Site Plan Application

Hudson Planning Commission	SITE PLAN REVIEW
Case No. 2021-1166	November 8, 2021

RAMCO SPECIALTIES
2021 EXPANSION
5445 HUDSON INDUSTRIAL PKWY, HUDSON, OH

Re: **5445 Hudson Industrial Pkwy - Ramco Addition**
Preliminary Engineering Approval - Viewpoint #21-1166

**UTILITY
PLAN**

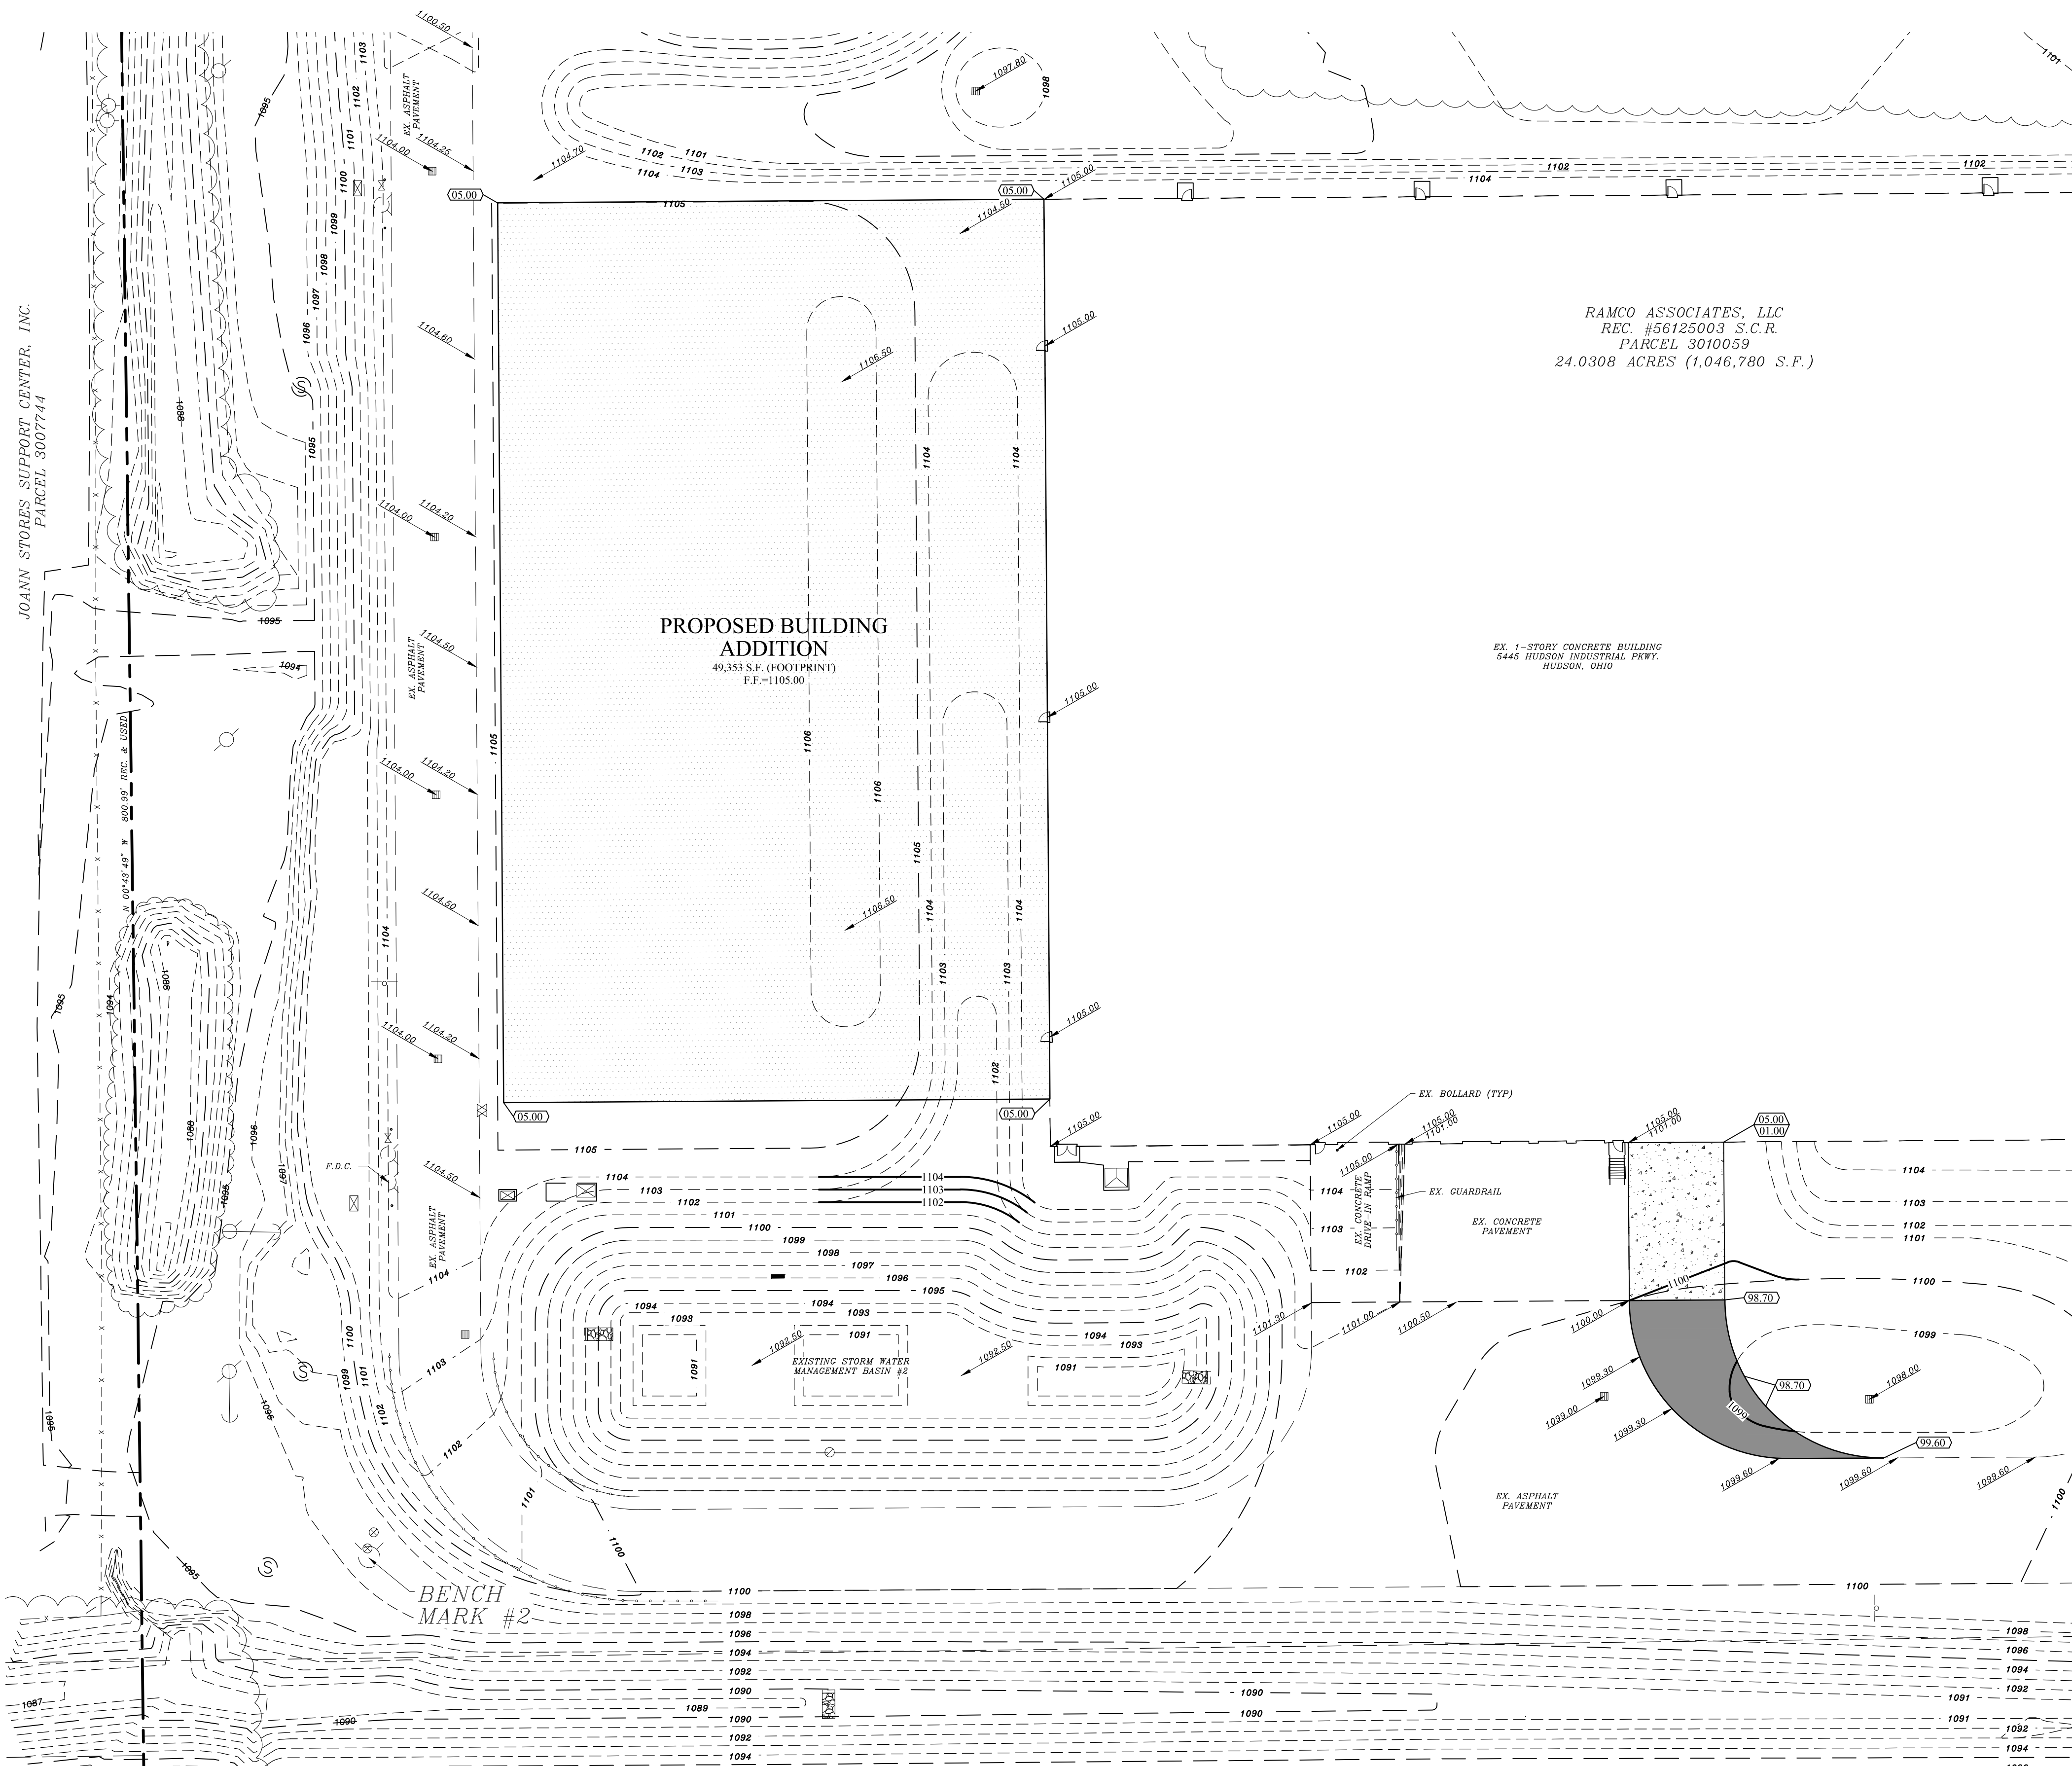
4. The City of Hudson Engineering Standards will be reviewed as part of the detailed improvement plan submittal of the project design. Since this site previously met City of Hudson storm water management requirements, the site the storm water must be controlled so that the pre-developed peak flows shall not be exceeded for all design storms.

5. The existing storm water management easements are shown as "unrecorded". Those easements and an updated Long Term Maintenance Agreement will be required to be recorded as part of this project.

LANDSCAPE PLAN
DRAWING NO:
L-100

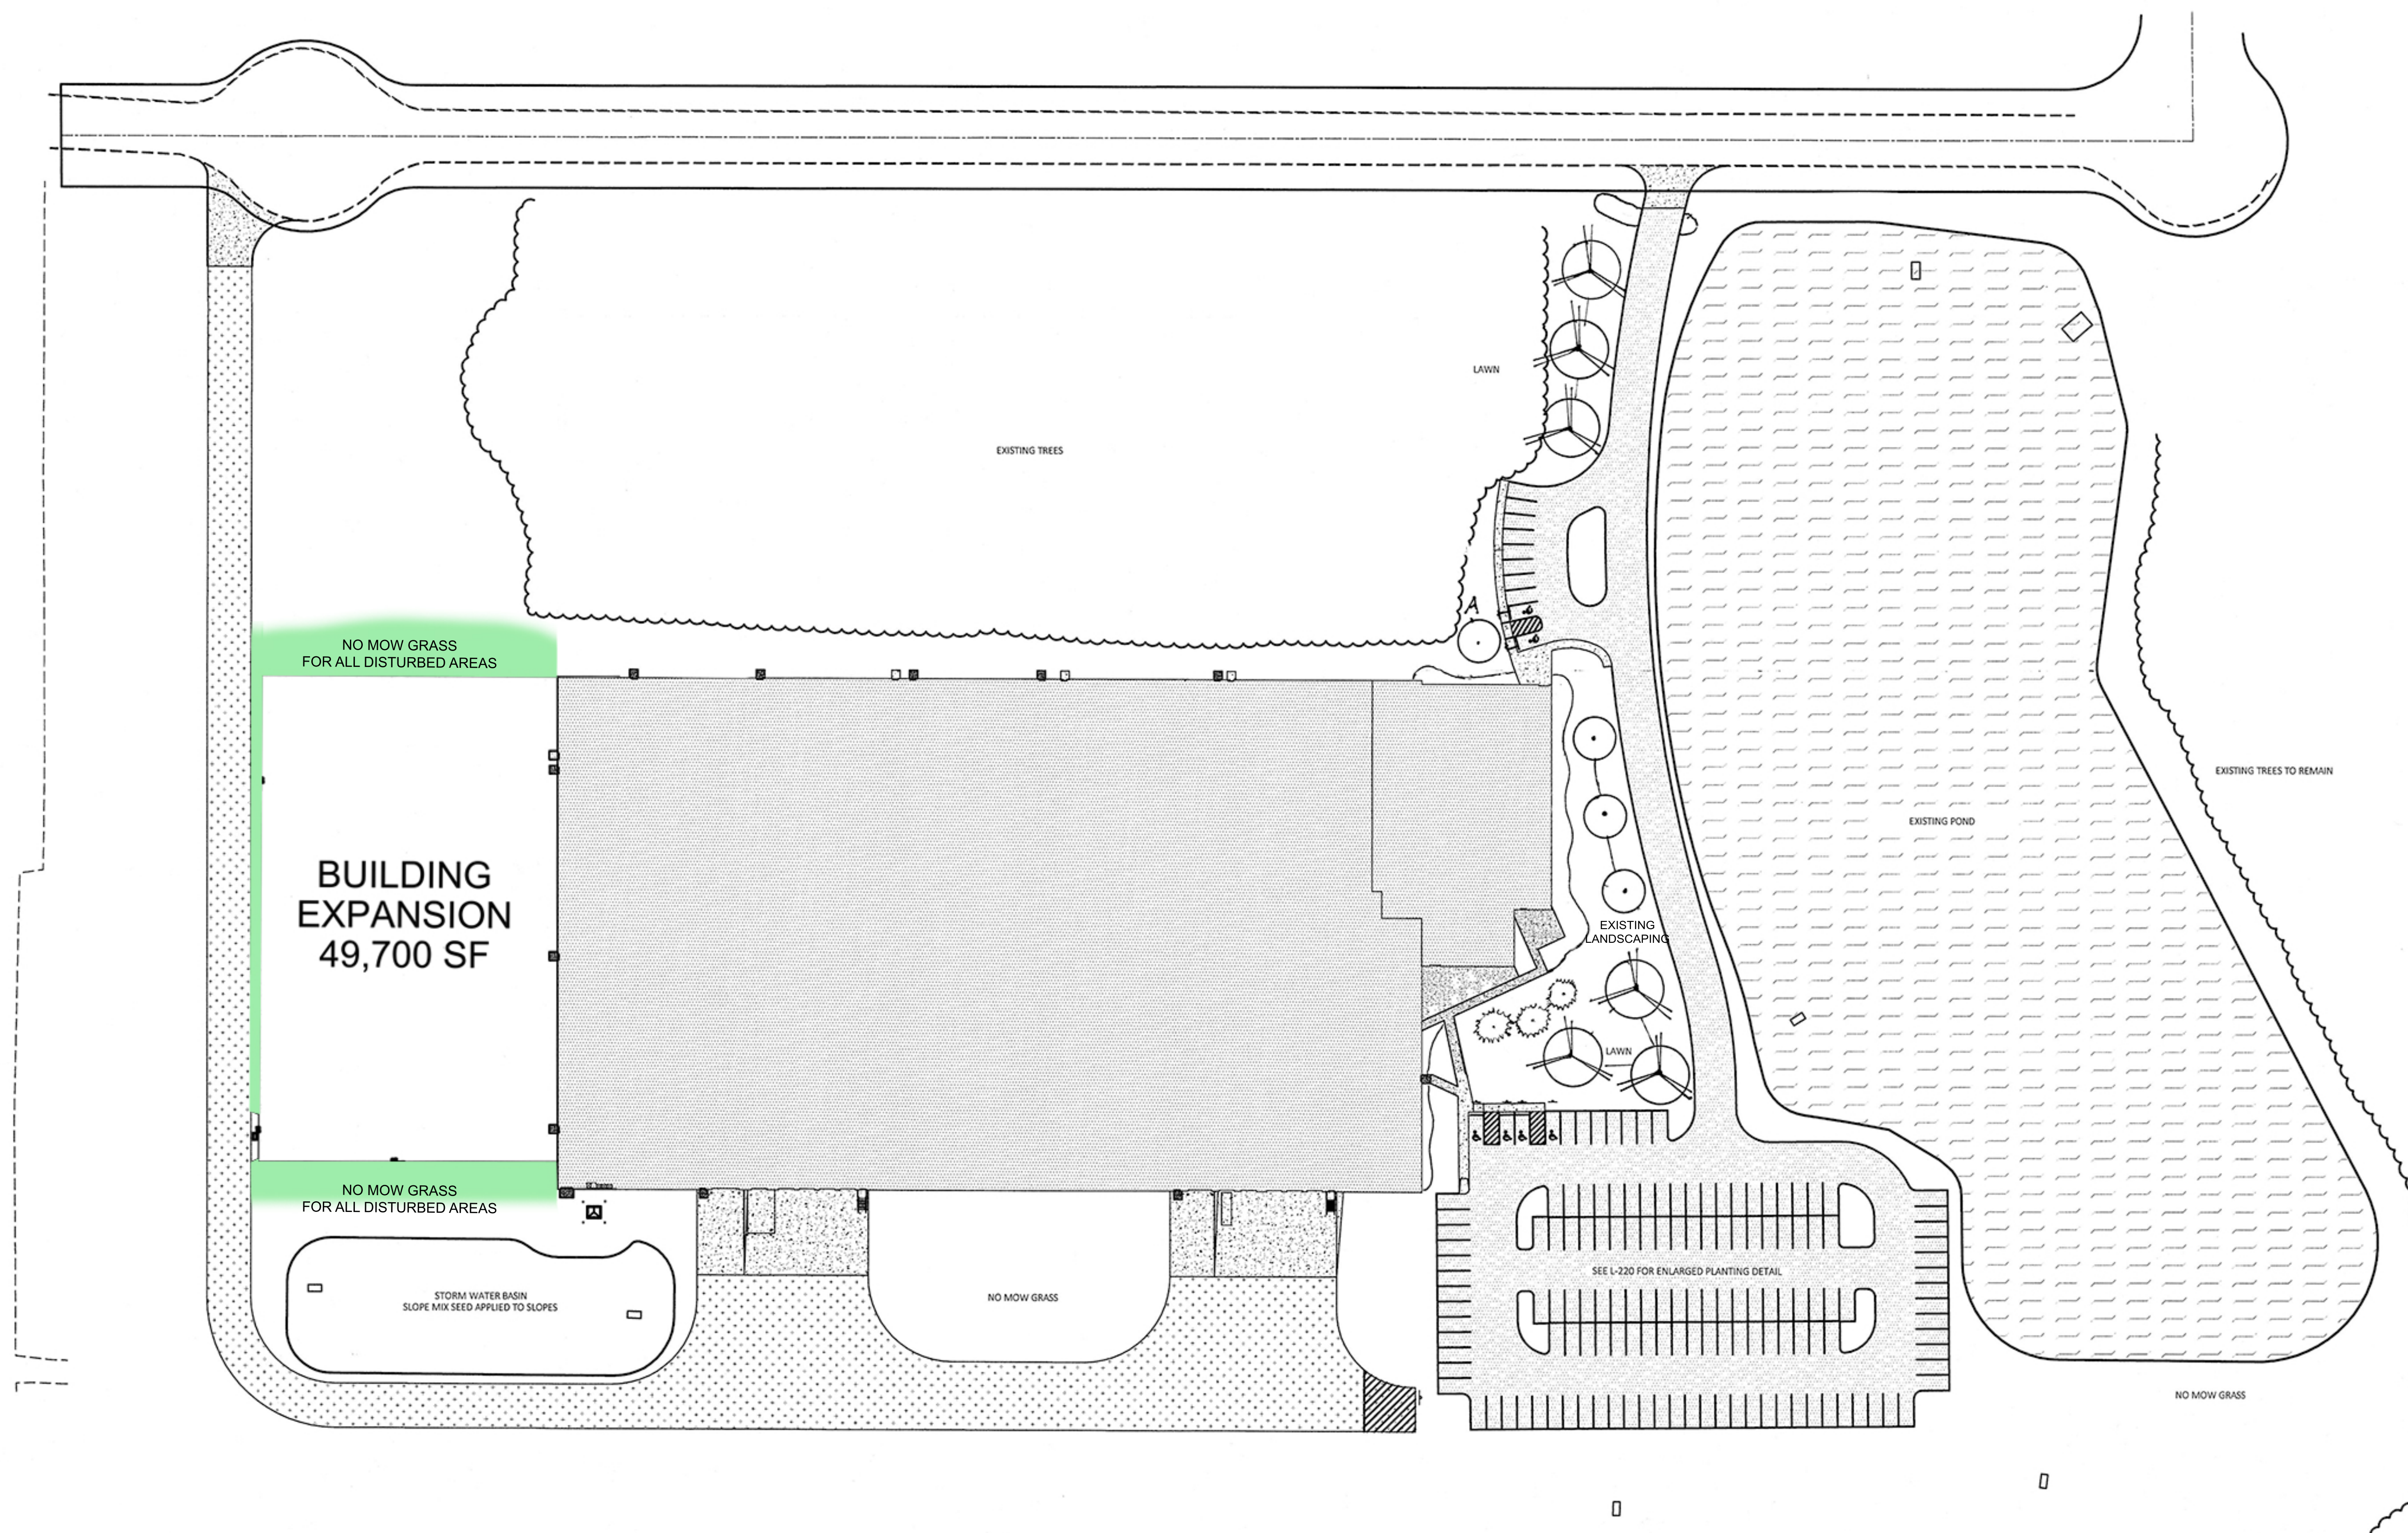
- Staff notes the existing landscaping along the property lines is in compliance with Bufferyard A. Staff recommends Bufferyard D (minimum 25 ft.) be installed between the addition and Hudson Industrial Parkway to meet the Land Development Code requirements for front yard landscaping as well staff's recommendation to the Industrial Design Subcommittee.

1. Landscape Bufferyard D (minimum 25 ft.) shall be installed between the addition and Hudson Industrial Parkway.
2. Applicant to submit an updated parking/employee calculation to verify compliance with Section 1207.12(f) "Parking Space Requirements".
3. Subject to the Planning Commission acceptance of the recommendation of the Industrial Design Subcommittee regarding the architectural design.
4. The comments of Assistant City Engineer, Nate Wonsick must be addressed per the November 3, 2021 correspondence.
